Work Order ID 88691

Item Name: 205 Skidtube bent detail

DRAWING NO. D2580	TITLE 205 SKIDTUBE ASSEMBLY	REV. E	DART AEROSPACE LTD ENGINEERING ORDER	D.E.O. NO. D2580-E-1	SHEET NO. SHEET 1 OF 1	SCALE NTS
DRAWN <i>JP</i>	CHECKED <i>ASS</i>	MFG. APPR. <i>EC</i>	APPROVED <i>[Signature]</i>	DE APPR. <i>[Signature]</i>		
DATE 11.12.13	DATE 11.12.13	DATE 11.12.13	DATE 11.12.13	DATE 11.12.13

CHANGE ALL C'BORED WELDED CROSSBOLT SPACERS TO SWAGED SPACERS

SECTION B-B D5-2
SCALE 5X

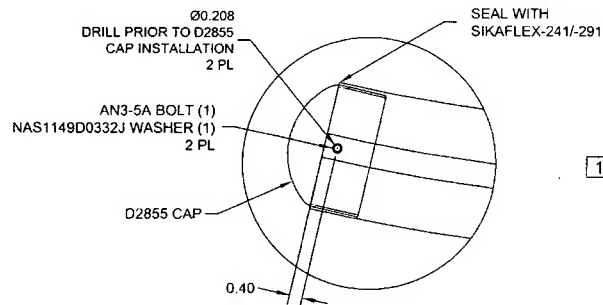
SECTION B-B, SECTION F-F, & SECTION I-I ARE AMENDED AS FOLLOWS
FOR ALL HOLES THAT WERE ORIGINALLY C'BORED:

1. INSERT D4202-1 SPACER, 20 PL (-041) OR 20 PL (-045) OR 25 PL (-047)
2. SWAGE TO Ø0.437 X 1.00 DEEP PER QSI 002
3. TRIM / GRIND FLUSH PER QSI 002

SECTION B-B, F-F, I-I
NOT TO SCALE

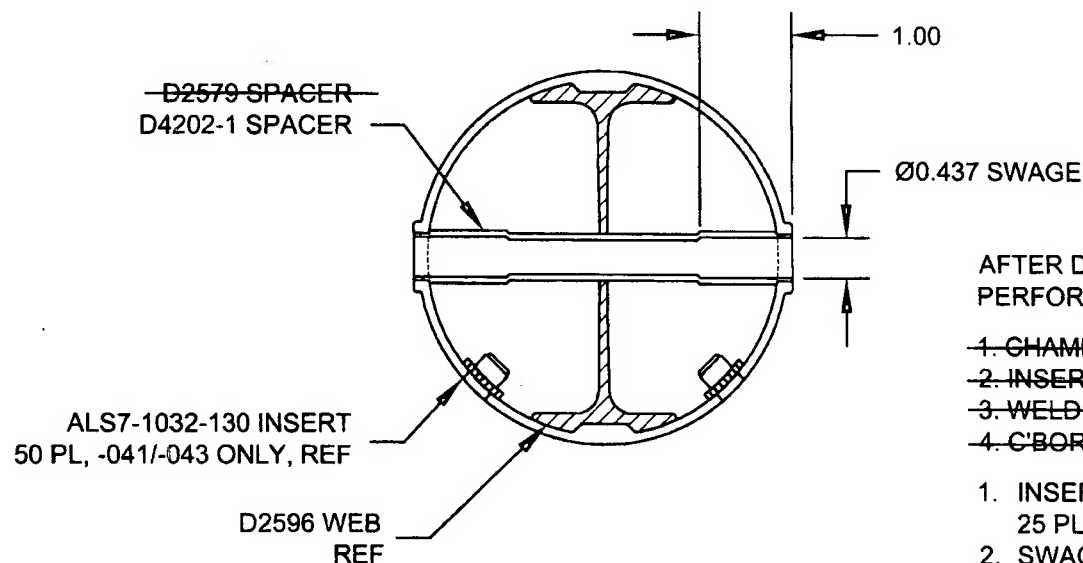
PURPOSE:

*** FOR -045 SKIDTUBE ONLY:**

WELD 4X D2579 SPACERS PER DWG
IN LOCATIONS MARKED "NO C'BORE".
REF SHEET 4 OF DWG.

AFTER DRILLING AND BENDING ASSEMBLY
PERFORM THE FOLLOWING FOR Ø0.508 HOLES ONLY:

- ~~1. CHAMFER HOLE 0.050 X 45°~~
- ~~2. INSERT D2579 SPACER (20 PLACES)~~
- ~~3. WELD INTO PLACE AND GRIND FLUSH~~
- ~~4. C'BORE D2579 SPACER TO Ø0.437 X 1.00 DEEP~~
